May 13, 2021

**Ref: Mechanical Equipment Noise Levels - Acoustic Analysis
Monmouth University Police Headquarters
400 Cedar Ave, West Long Branch, NJ 07764**

Figure 1: Monmouth University Police Headquarters Site

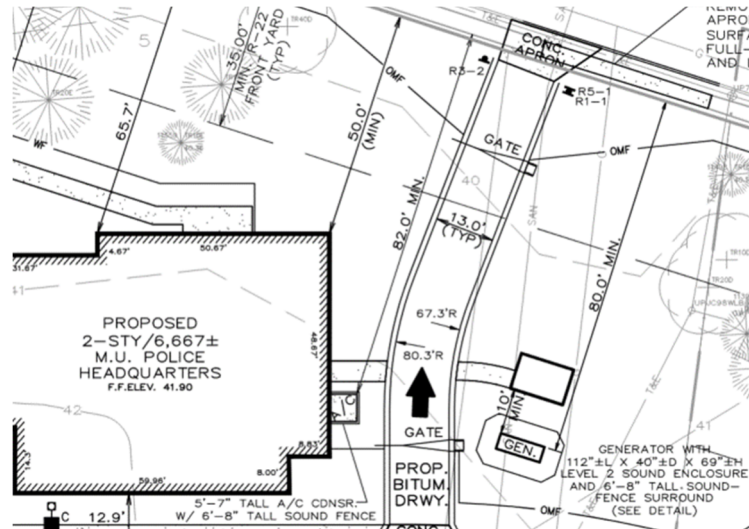
The Police Headquarters is proposed to be located on N.J.S.H Route 71, between Elmwood and Pinewood Avenues. Directly adjacent (plan east) of the headquarters are the coordinated locations for the HRU and generator. The Route 71 street line of University-owned property is considered the nearest residential property line for purposes of this analysis. The property line is approximately 82 feet from the HRU and 80 feet from the generator. Figure 1, provided below, depicts the site layout and distances from each sound source to the property line. We have reviewed the proposed layout (Layout, Circulation & Parking - 1; Sheet 7 of 30; Prepared by William E Fitzgerald, PE; Dated 12-03-19; Revised thru: 05-12-21) and confirm the distances between each unit and the property line are acoustically acceptable in conjunction with sound barrier fence construction as coordinated.

Figure 2: Proposed Sound Barrier Fence

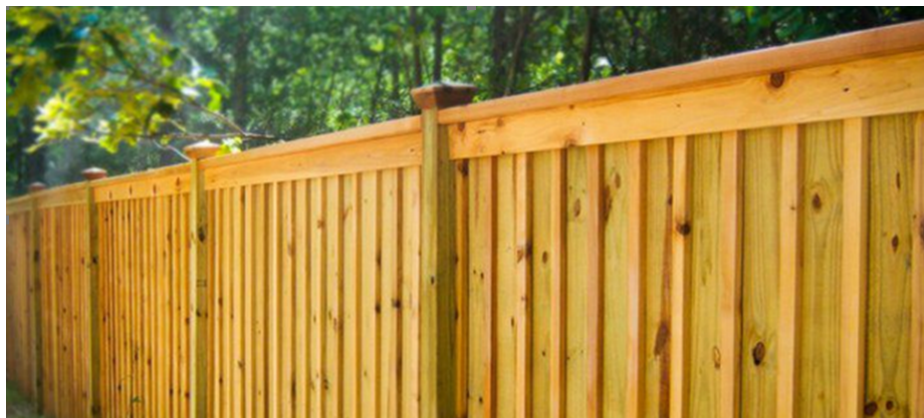
As previously mentioned, sound barrier fences surrounding the HRU and generator are required to meet noise regulation limits. Fence construction as outlined below has been coordinated by the design team and meets all acoustic requirements.

- 1) Fence will be 6.5 feet in height or higher.
- 2) Fence will not include gaps at the bottom.
- 3) Fence will be constructed of solid faced timber (board-and-batten style) with no gaps between boards.

The fencing around the mechanical units will be of similar construction to the example pictured in Figure 2 below.
